MOD2024/0398

10.	04.07.2024	PROPOSED MODIFICATION OF CONSENT 4.55 DA 2021/1824 DEMOLITION MCO1-MC16	D	SF

PROPOSED : MODIFICATION OF CONSENT 4.55 DA 2021/1824 ALTERATIONS AND ADDITIONS, AND POOL TO EXISTING RESIDENCE.

ADDRESS : 23 HAY STREET COLLAROY NSW 2097

SHEET No : **MC01**

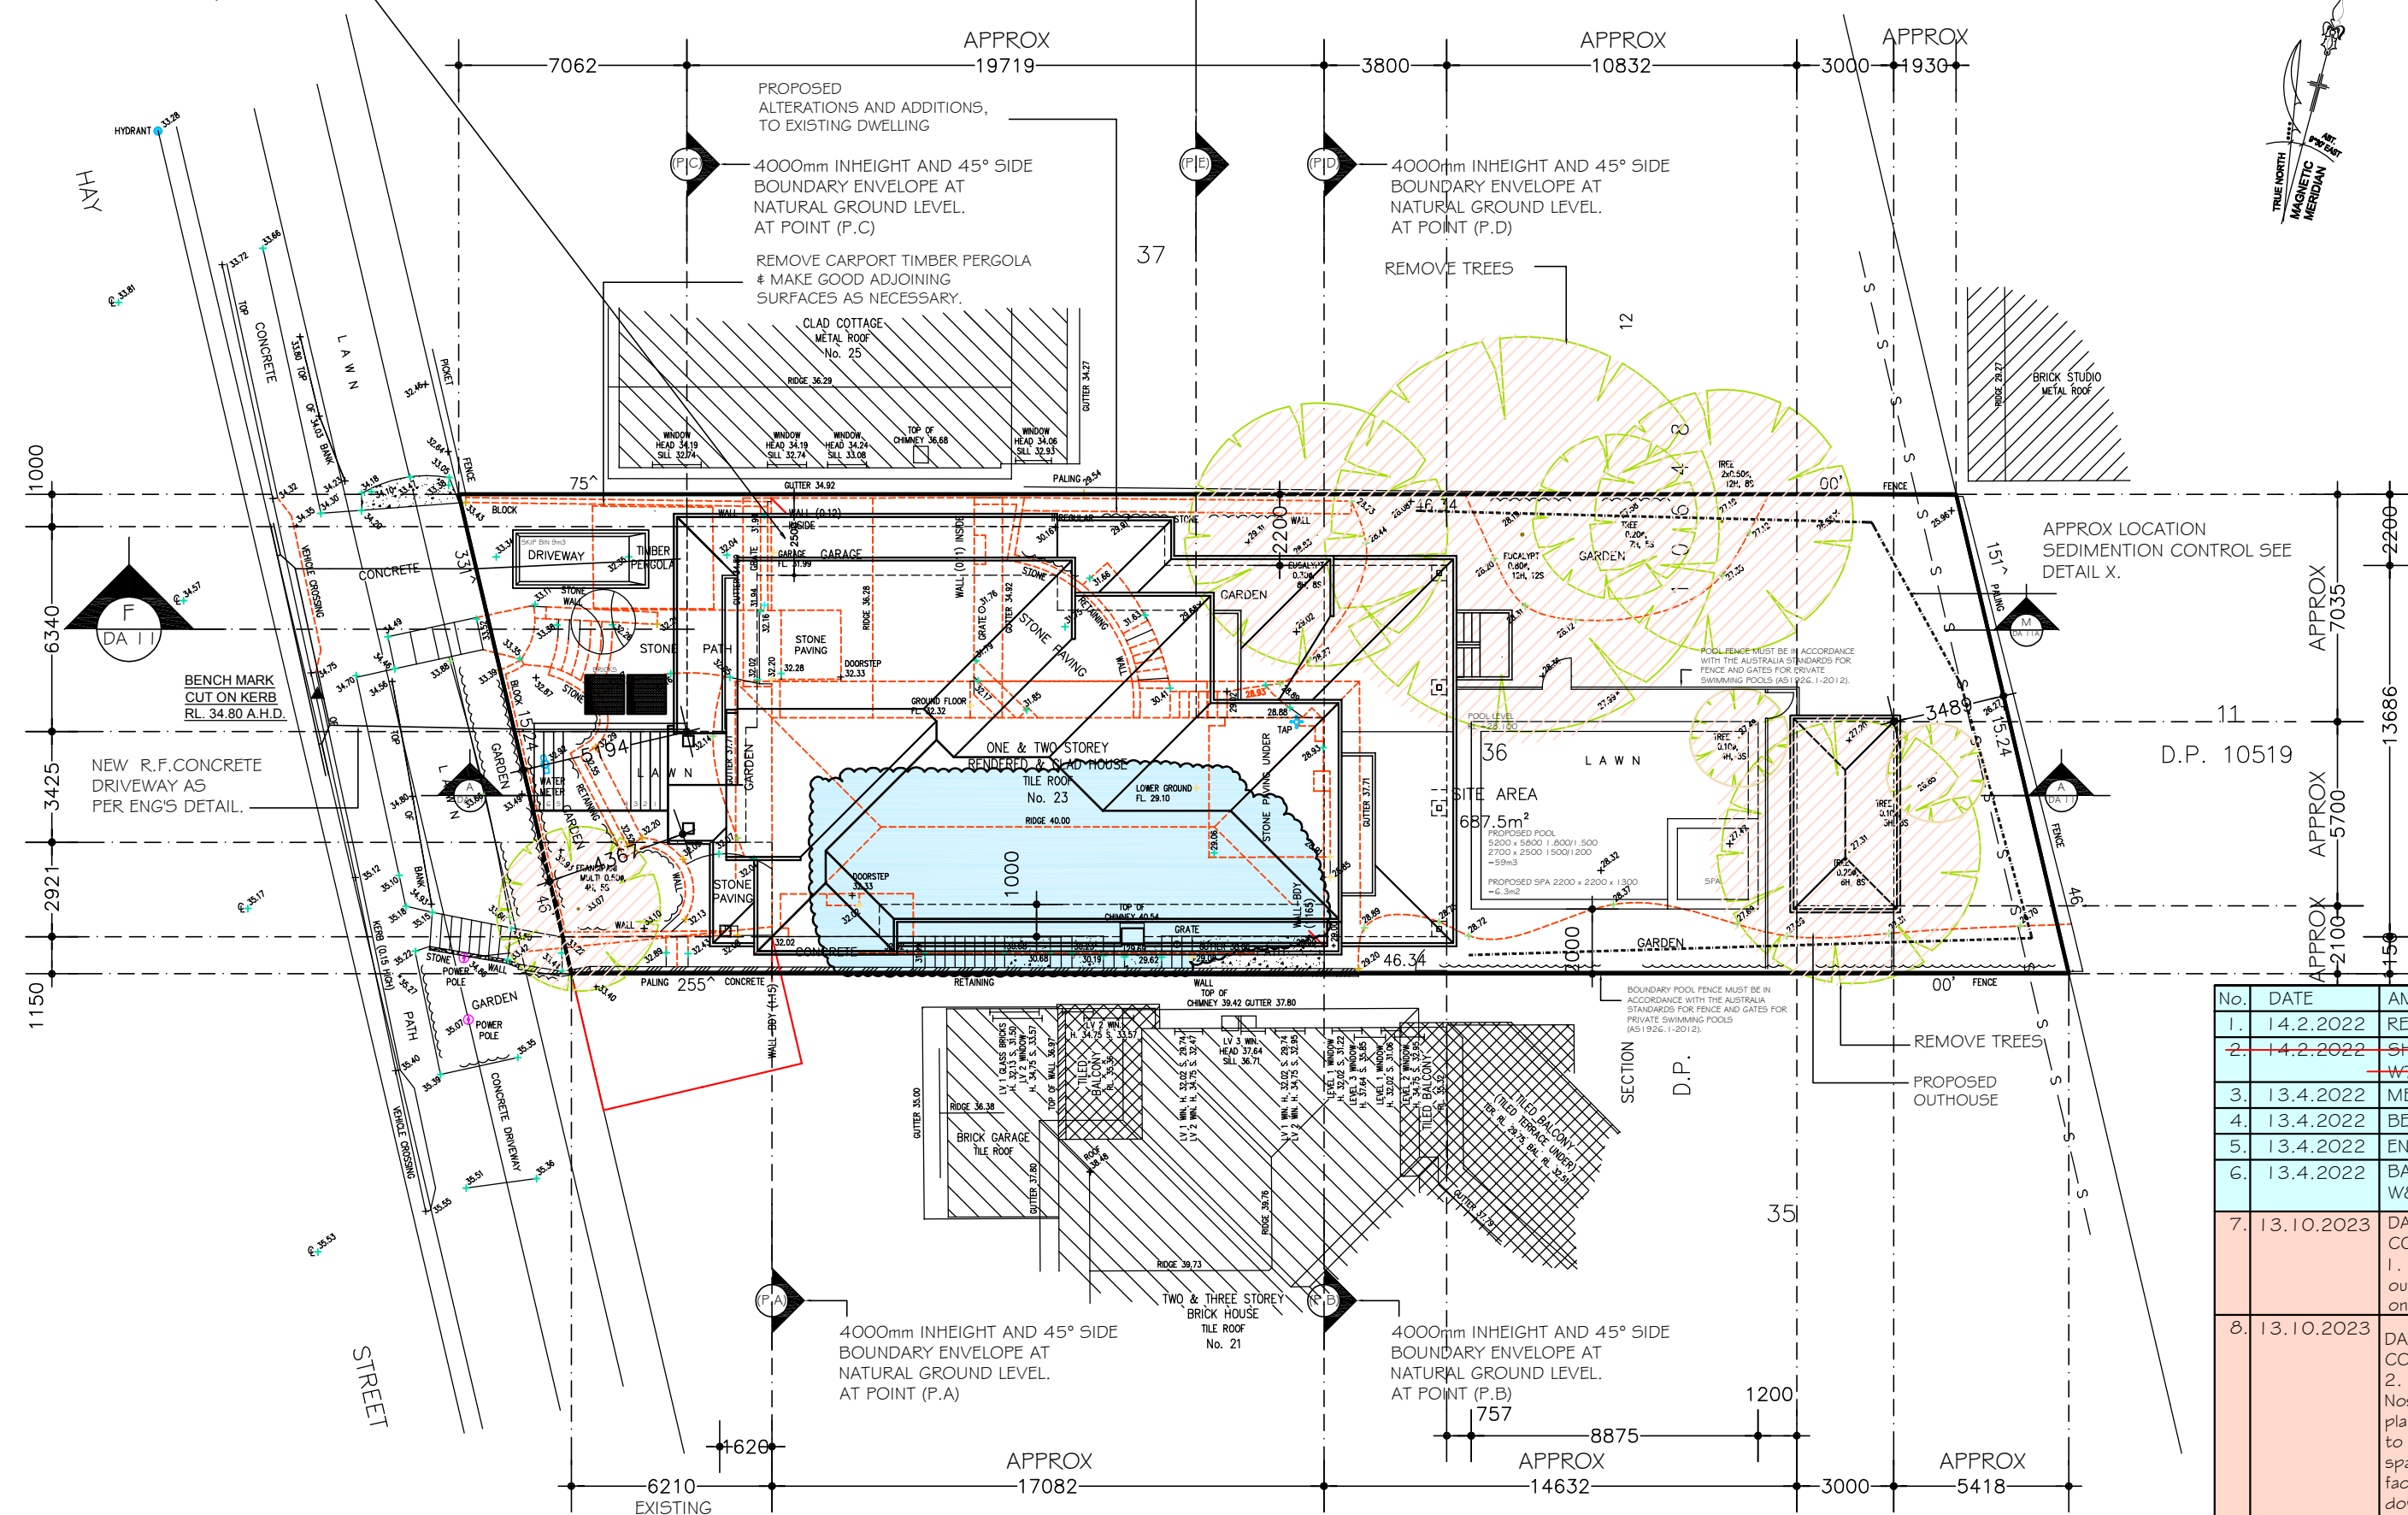
No.	DATE	AMENDMENTS	REV	BY
1.	14.2.2022	RELOCATE REAR EXTERNAL STAIRS	A	SF
2.	14.2.2022	SHELF TO W6 KITCHEN AND W7 DINE WINDOWS ONLY	A	SF
3.	13.4.2022	MEALS WALL SETBACK 2200	B	SF

4.	13.4.2022	BED 2 SIDE SETBACK 3590	B	SF
5.	13.4.2022	ENS SIDE SETBACK 2500	B	SF
6.	13.4.2022	BAHAMA SHUTTERS TO W 5 ,W6,W7 W8,W24,W25	B	SF
7.	13.10.2023	DA2021/1824 CONDITION 7. 1. A 600mm privacy shelf is to project outwards below the windows W6 and W7 on the northern elevation.	C	SF

8.	13.10.2023	DA2021/1824 CONDITION 7. 2. The 'Bahama Shutters' shown on Sheet Nos. DAO8 and DAO9 of the stamped plans are to have fixed louvers (with a maximum spacing of 20mm), in a 45 degree angle facing downwards, in a material that complements the design of the approved development. The 'Bahama Shutters' are to only be able to open outwards at the base 15cm.	C	SF

9.	13.10.2023	3. The northern elevation of BEDROOM 3 and Ensuite located on the First Floor and shown on Sheet no. DAO6 are to be set back a minimum of 2.5m from the northern boundary.	C	SF

No.	DATE	AMENDMENTS	REV	BY
12.	11.09.2024	FIRST FLOOR SOUTHERN WALL BEDROOM 1, WIR AND ENS MOVE 1000 AND DELETE WINDOW 22	F	SF

SHEET No :
MC06

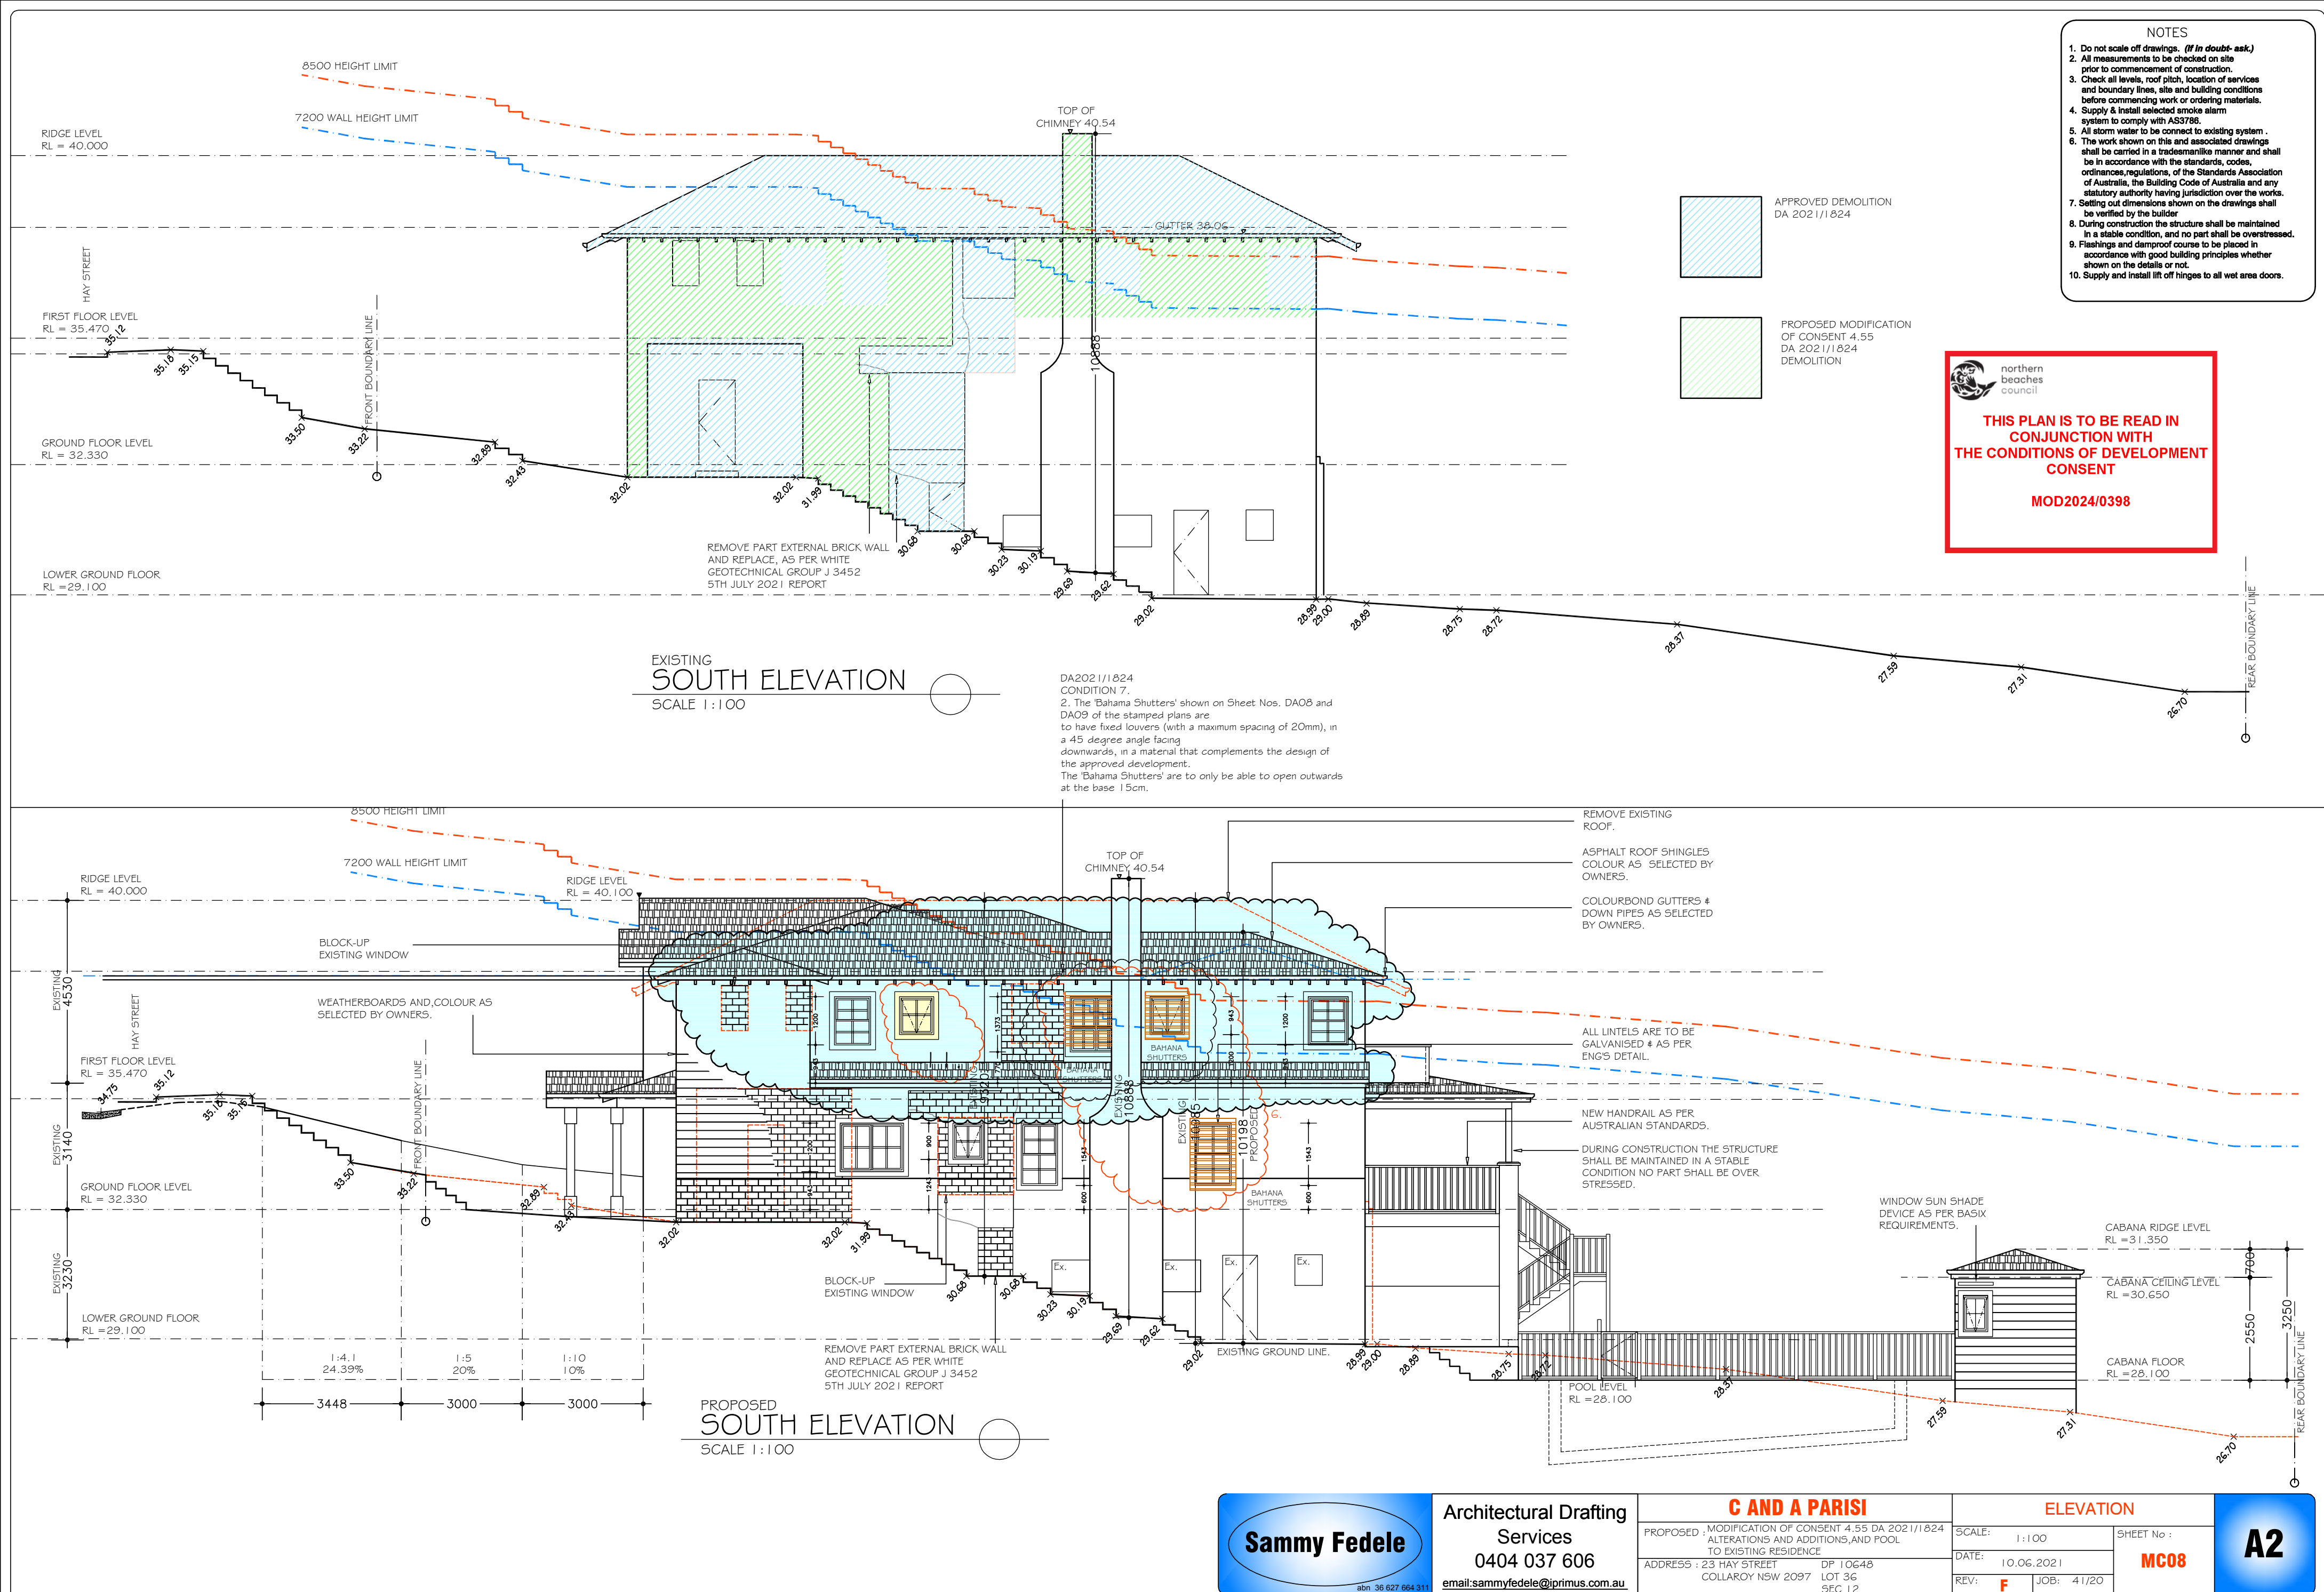
3. The northern elevation of BEDROOM 3 and Ensuite located on the First Floor and shown on Sheet no. DAO6 are to be set back a minimum of 2.5m from the northern boundary.
